BREAKERS
HOTEL
RENOVATION

Breakers Hotel Elevator Tower Height Increase Request

Breakers Hotel Window System Approval
November 7, 2019

A2.09

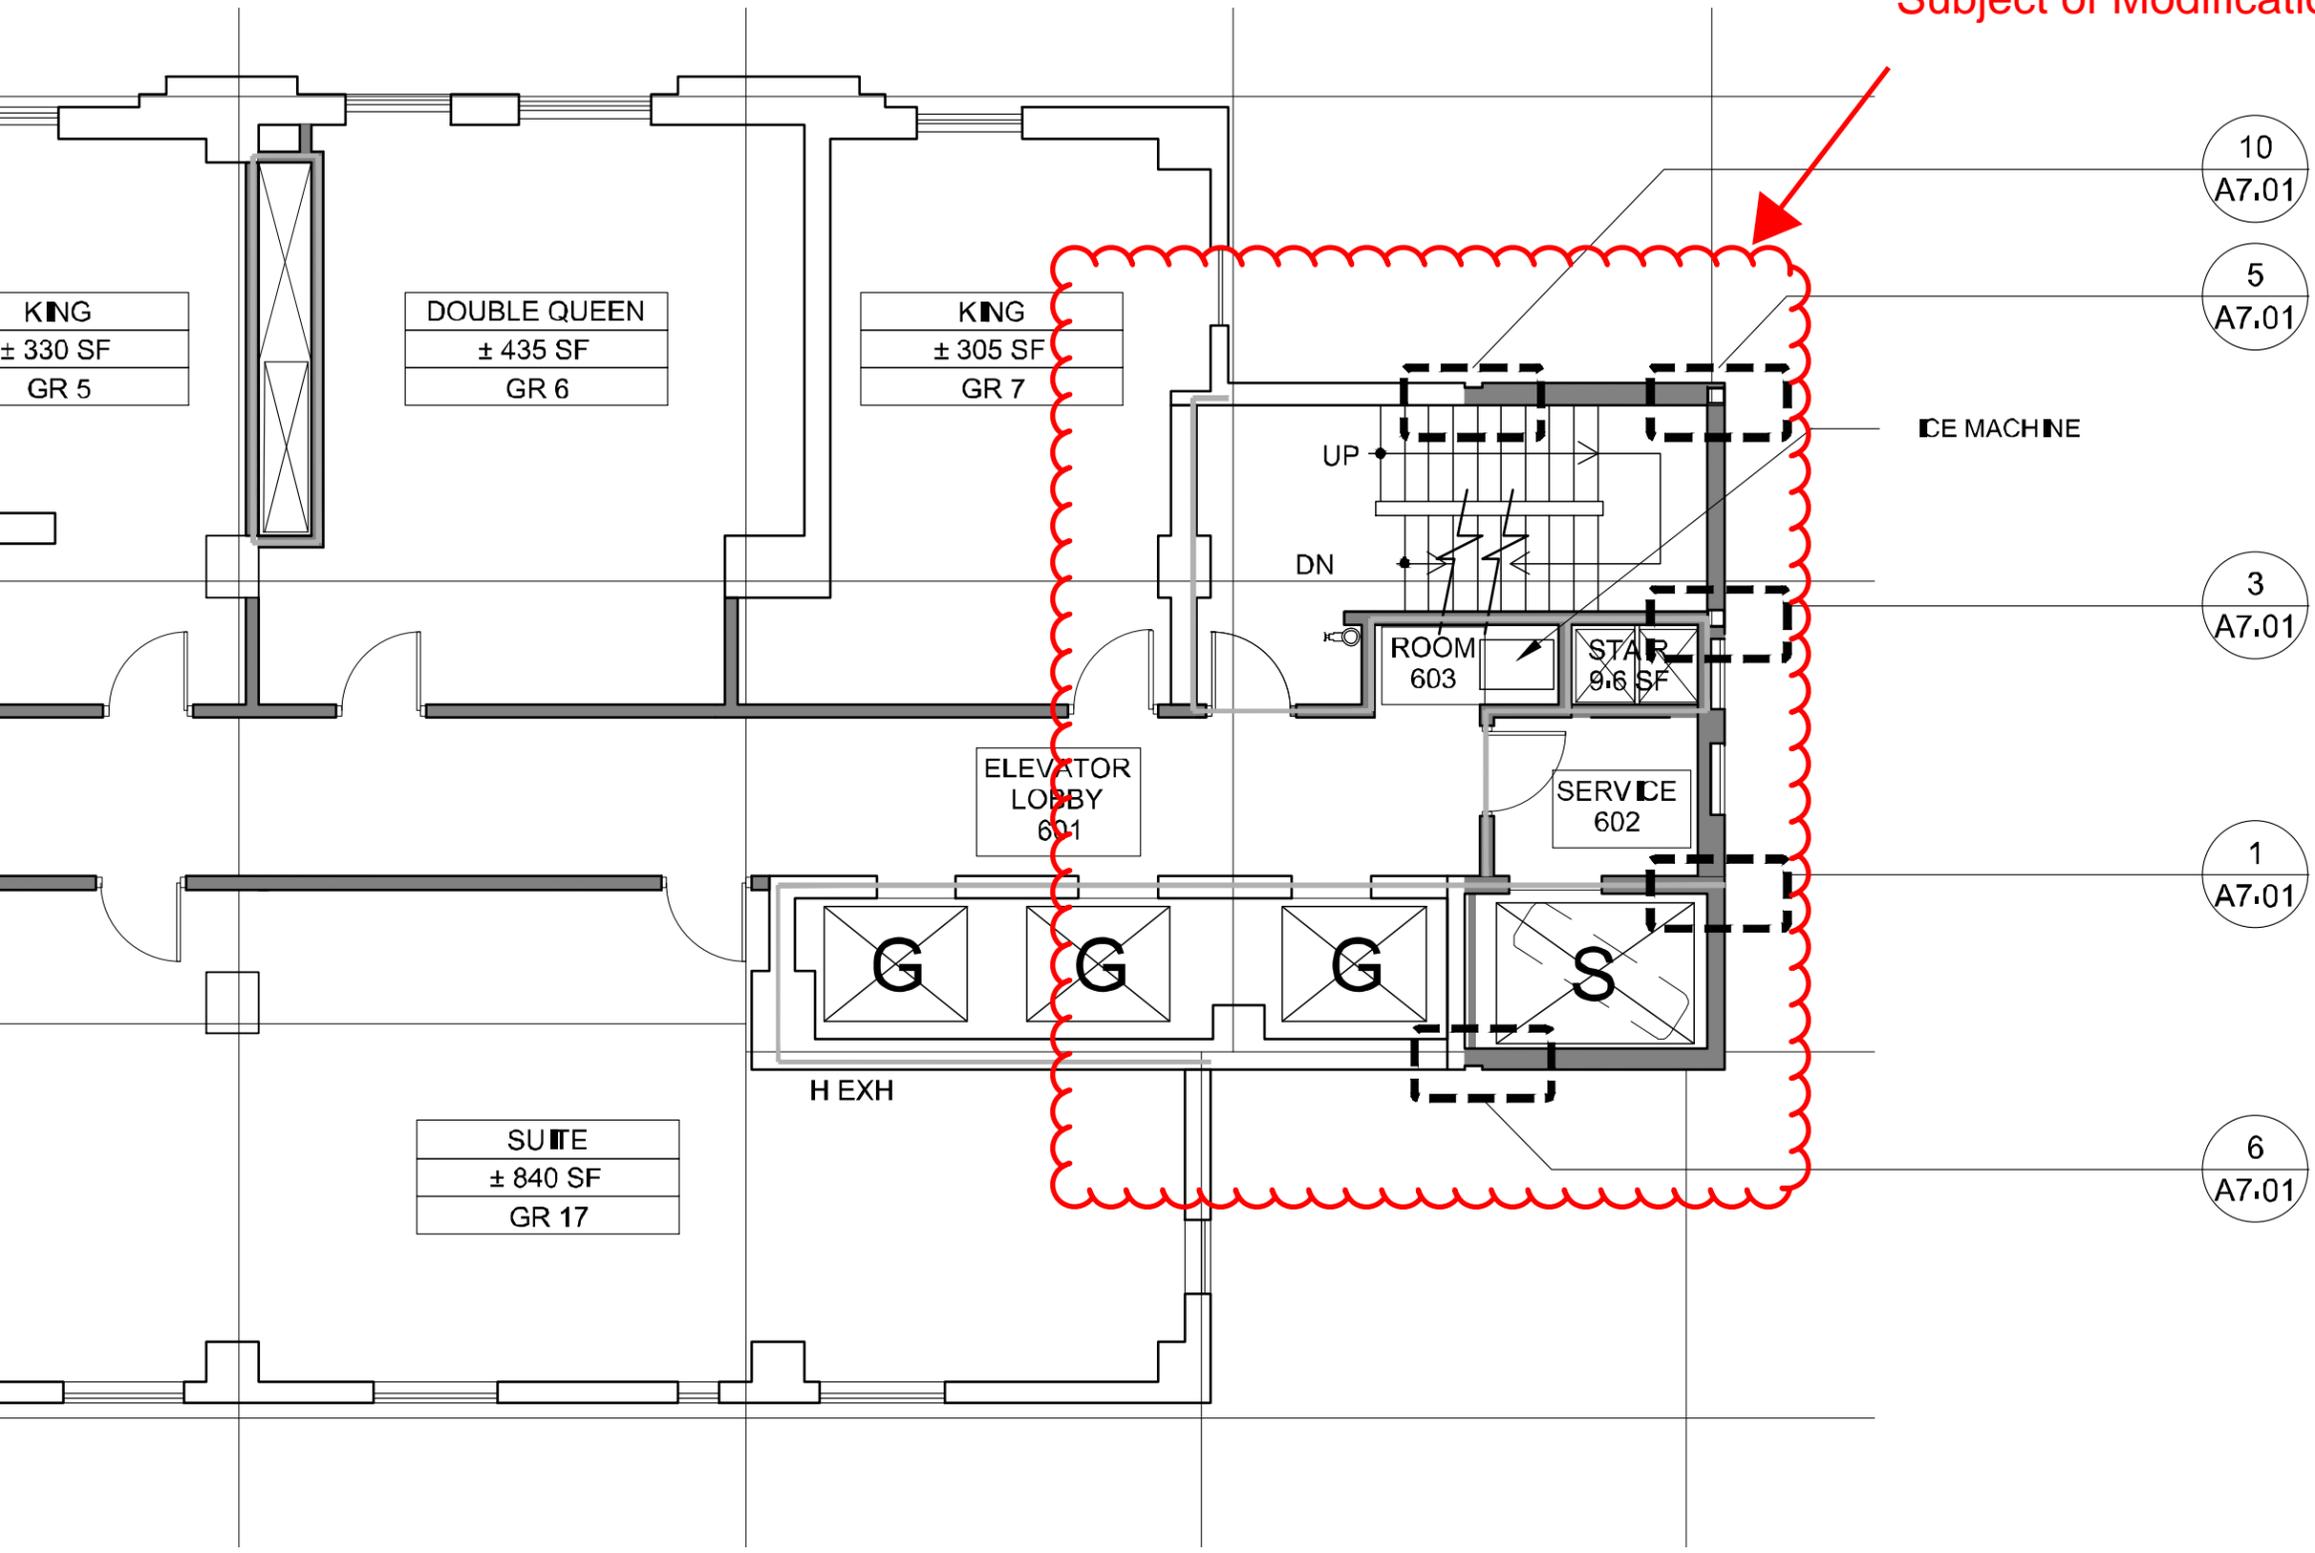
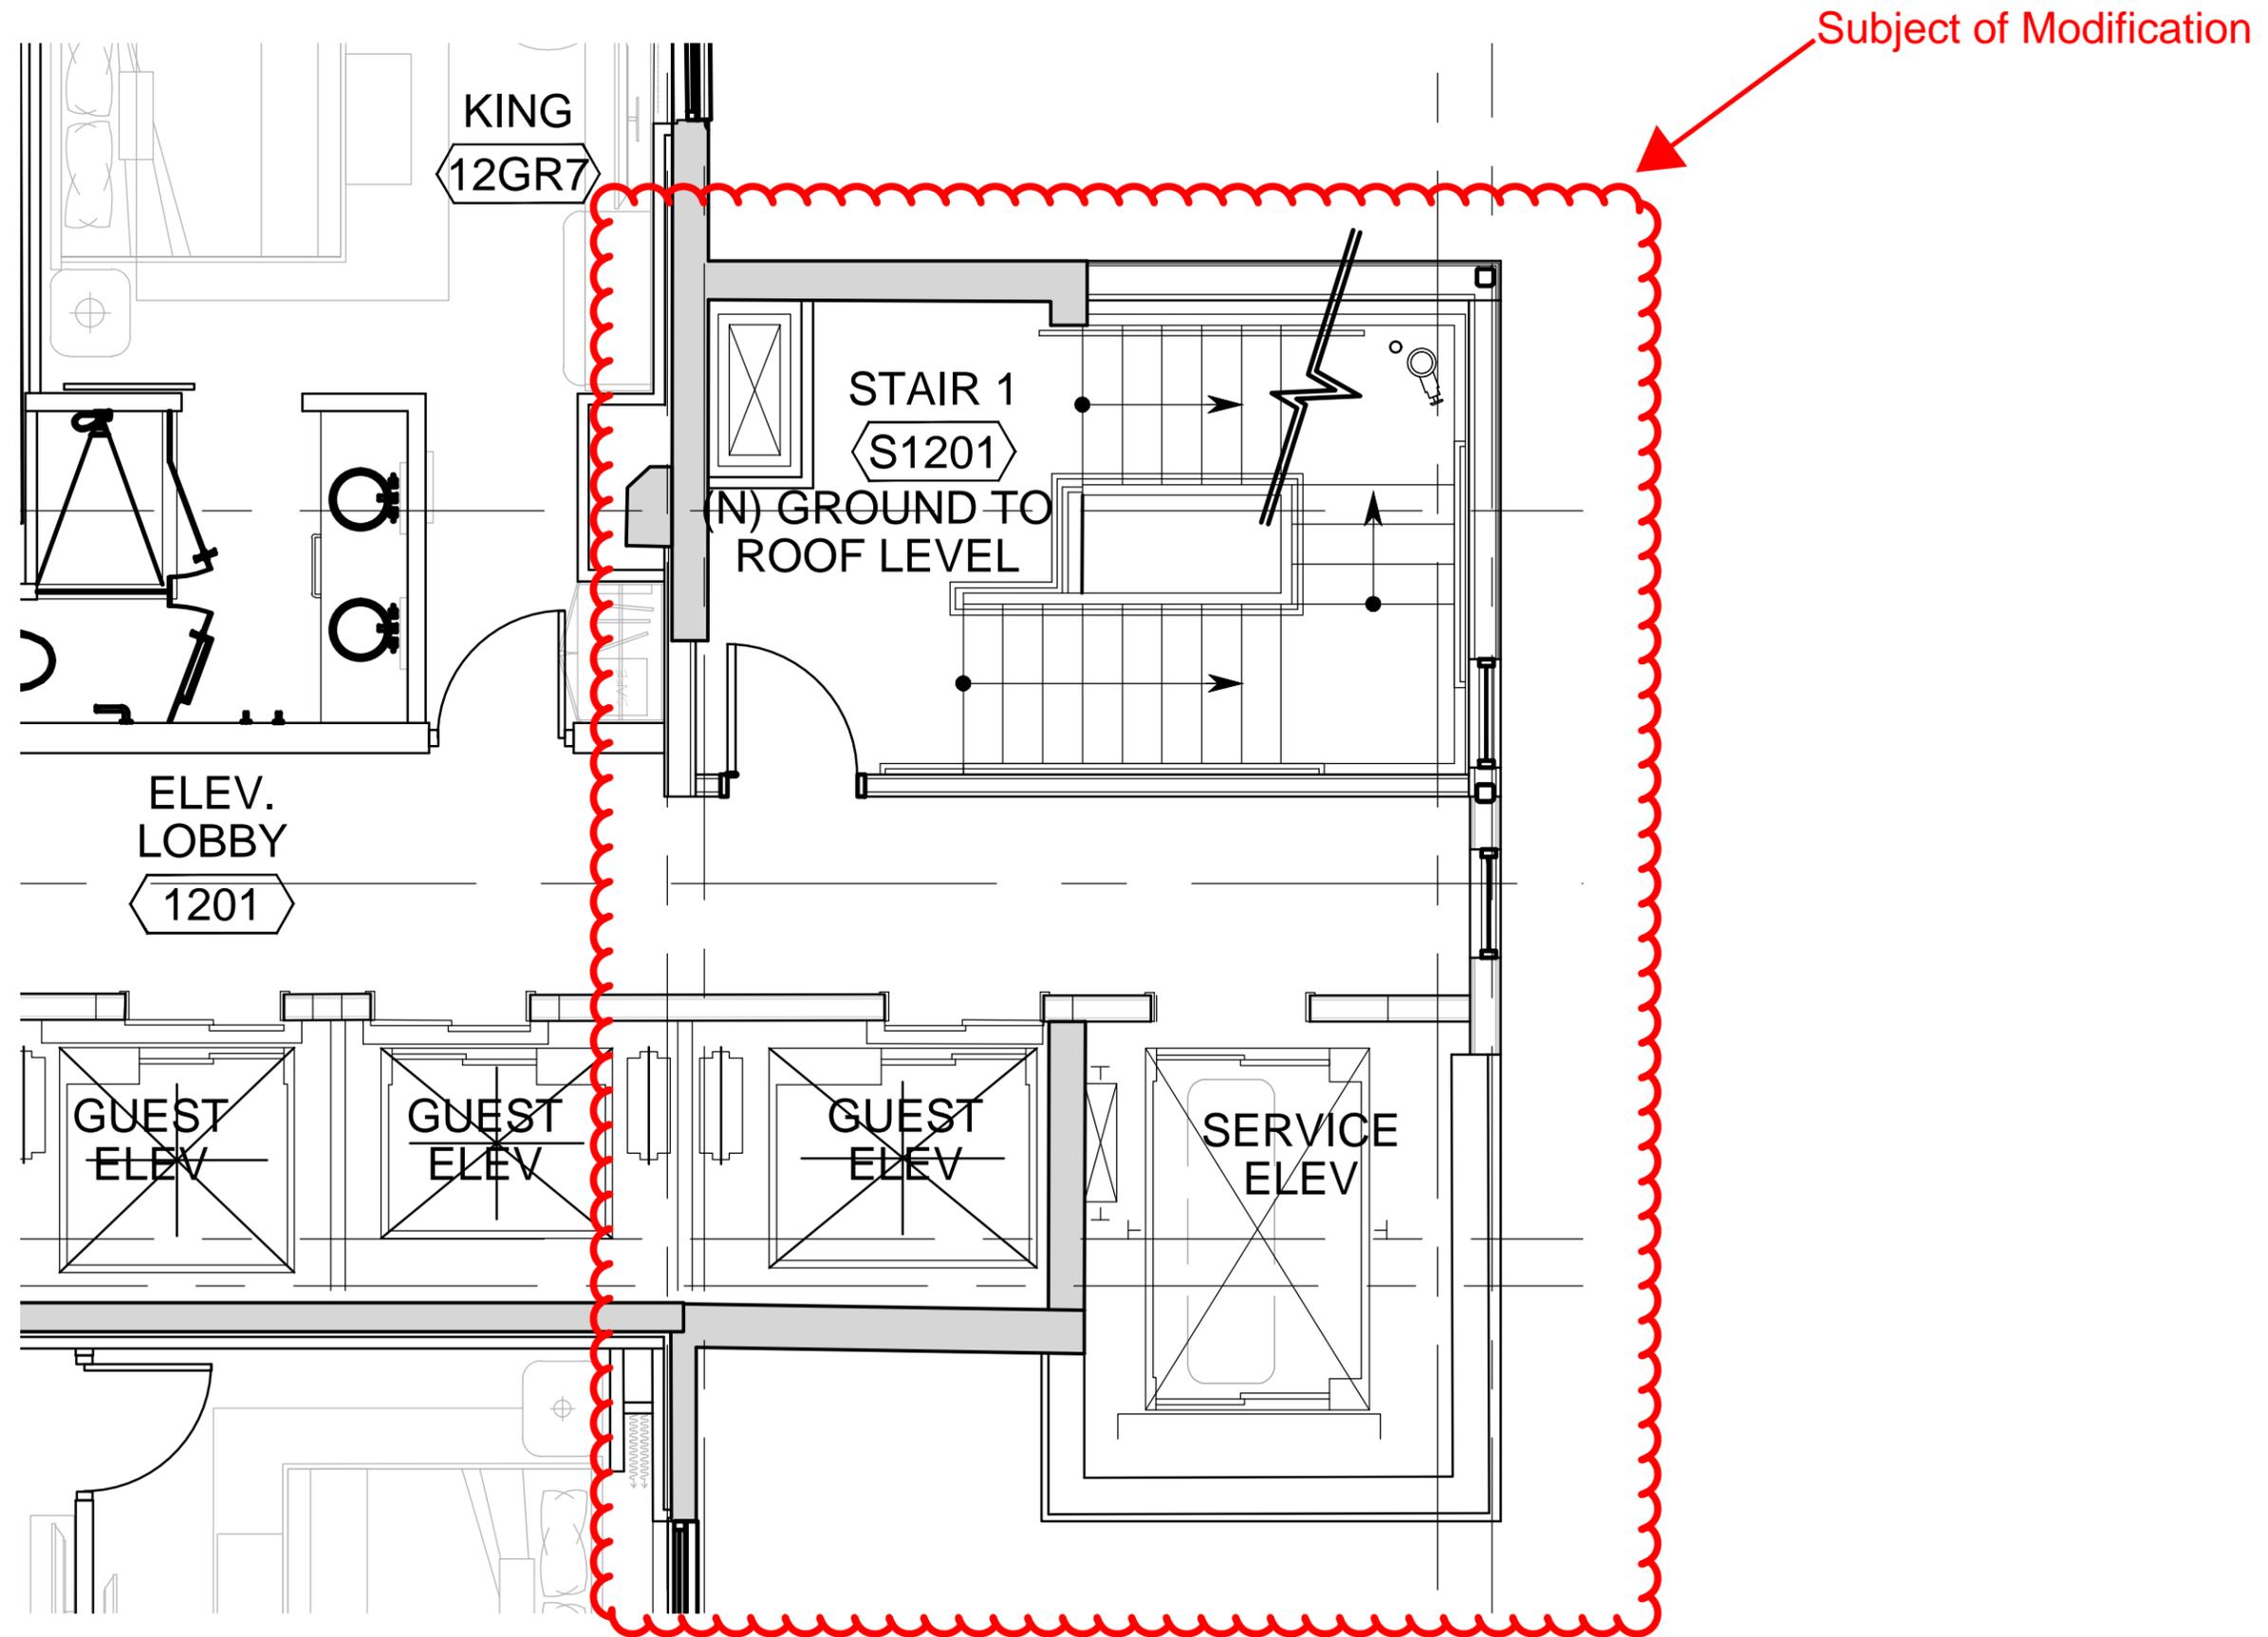
Subject of Modification -
See Enlarged Plan

Subject of Modification - See Revised Enlarged Plan
